Technical Bulletins Sorted By Bulletin Number
Generated 12/31/92

BULLETIN NO.: I/O:02

PRODUCT: 26-1171 Telephone Interface II

Figure 6

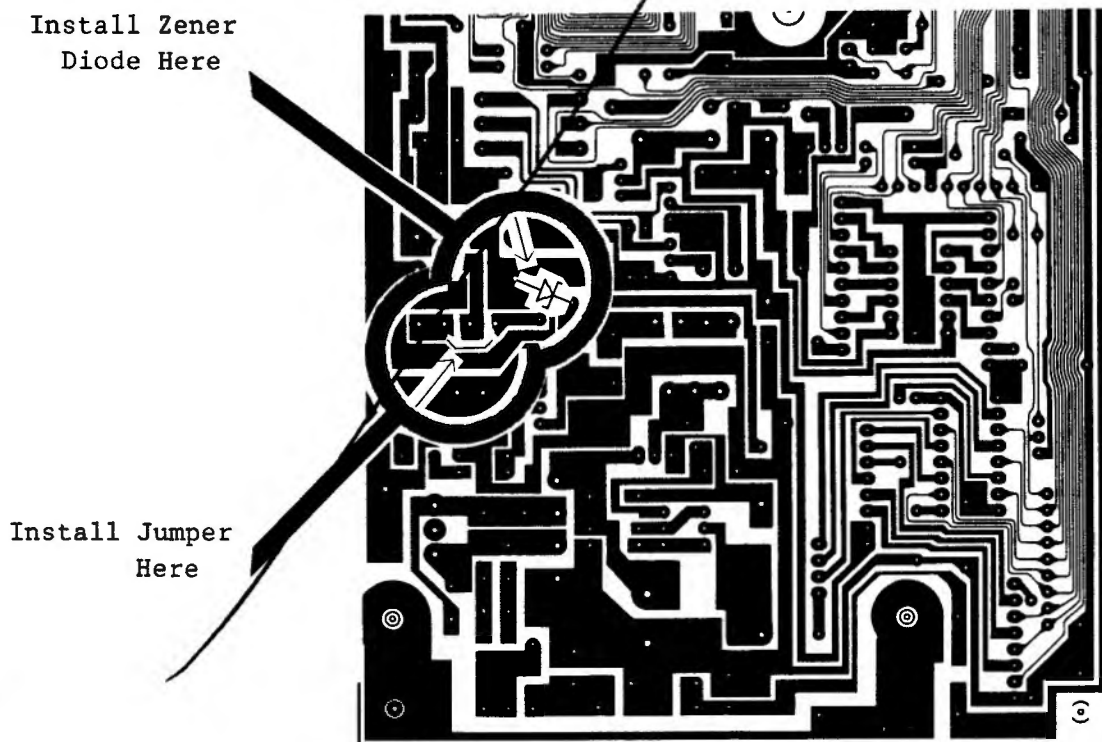
- 9.) On the solder side of the circuit board a jumper must be added. Locate the remaining hole on the solder pad for L1. This hole has a trace that leads to Q10, the 78L05 voltage regulator. Jumper from this point to the pad connecting coil L1 and the fuse, using insulated wire of 20-22 GA. See figure 6.

- 10.) On the solder side of the circuit board a 27 volt zener diode must be added between the emitter of Q9 and ground, with the cathode (banded side) connected to the emitter. See figure 6.

Figure #1

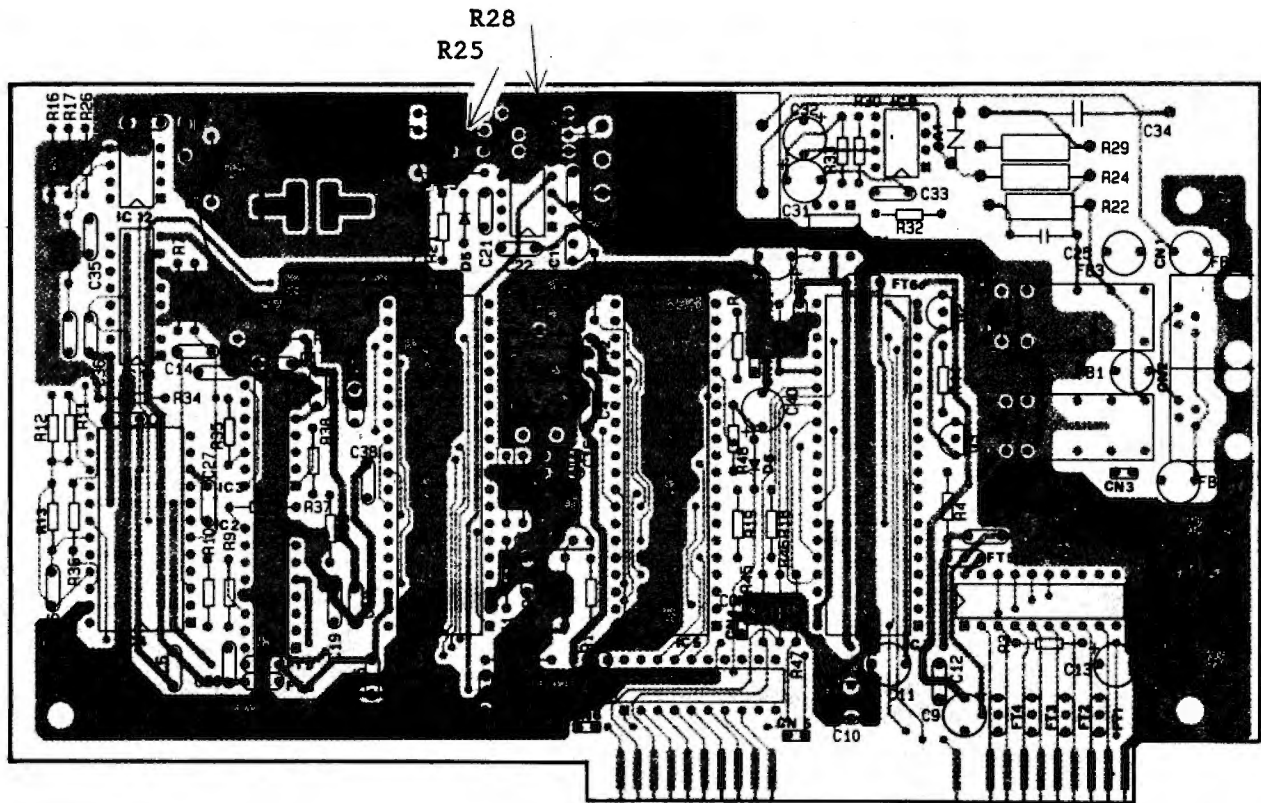
If this resistor needs to be added then change the resistor value of R25 from 470 ohms to 450 ohms to compensate for the decreased transmit power by the addition of the 10K ohm resistor at R28. Refer to Figure #1 for locations of the affected components.
